**PROJECT CHANGE REVIEW FORM**

**PW PROJECT NAME:** *Lockwood-Dignowity Park Improvements Project*

**PW PROJECT NUMBER:** *23-01676*

**Straight Line Management**  
**Change Proposal Request 01- A Hardscape Sewer Revisions**  
**Add a Second Porta-Loo**

2021-07-16  
 ISSUE FOR BID AND LATEST SITE  
 HARDSCAPE FLATWORK  
 COMPARISONS

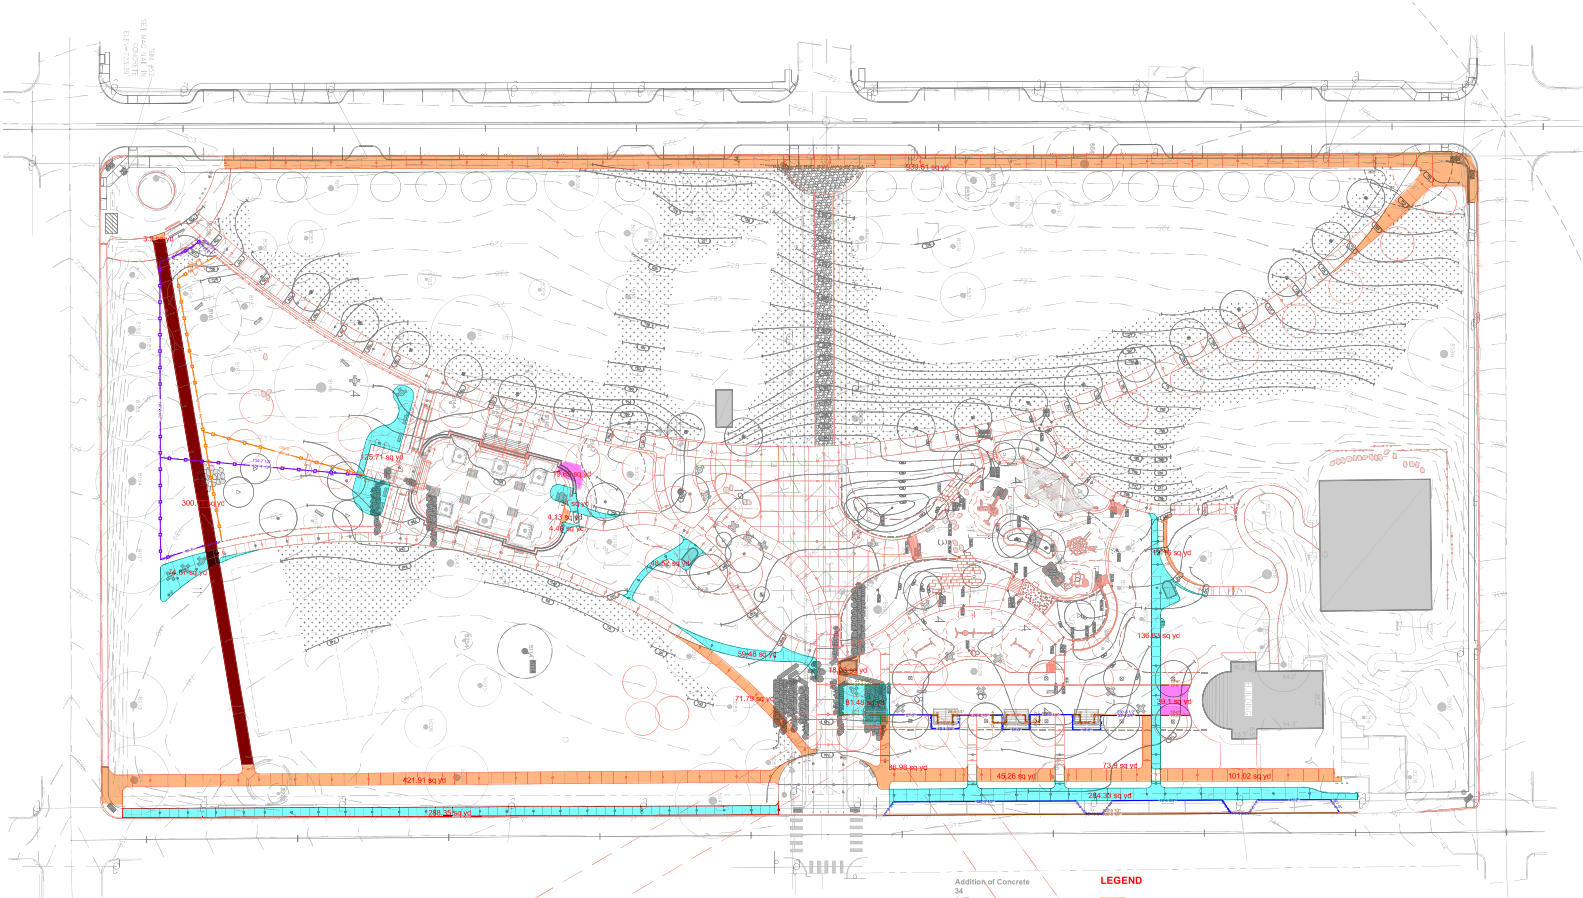
*Justification PR01A:* This CCR is associated with the purchase, delivery, and installation of a prefabricated restroom unit otherwise known as a Portland Loo by Straight Line Management and Madden Fabrication. The unit is to be installed in Lockwood Park and will serve the basketball court, playground, and swing areas and will complement the unit to be installed in Dignowity Park that serves the dog park, playfield, and Harmony House Plaza. Due to lead time for fabrication and delivery, the installation of the Lockwood prefabricated restroom will be scheduled for after the park construction is completed. As the Dignowity Park restroom is scheduled to be completed with the current park work, the park would be able to open for beneficial use by the public while the General Contractor awaits delivery of the Lockwood unit. This is an addition in the amount of \$184,145.50 and is acceptable.
